Subject: FW: Block A2 / A3 amendments S73 application ref. X/25/99588 - Lower Acre

In response to Andre's comments, I have spoken with our Technical Team and they have confirmed the following:

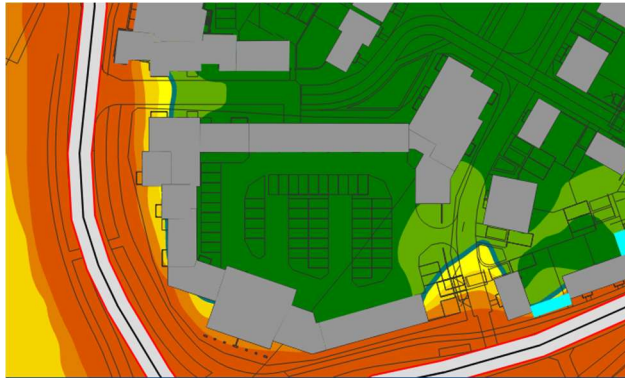
- As part of the acoustic strategy there are 3 levels of treatment depending where the plot is located on site.
- Wates has been procuring the suppliers glazing data sheets. To demonstrate compliance and discharge for conditions 30/31.
- I have discussed the external acoustic impact to the site, and it makes no difference with the change of the apartment blocks. The current strategy still stands, see extract of heat map below.

- Current with new buildings.
- Original strategy doc, with different shape building.

- Once Ian Sharland has completed their condition addendum report this will confirm the acoustic spec etc in accordance with the planning approved strategy.
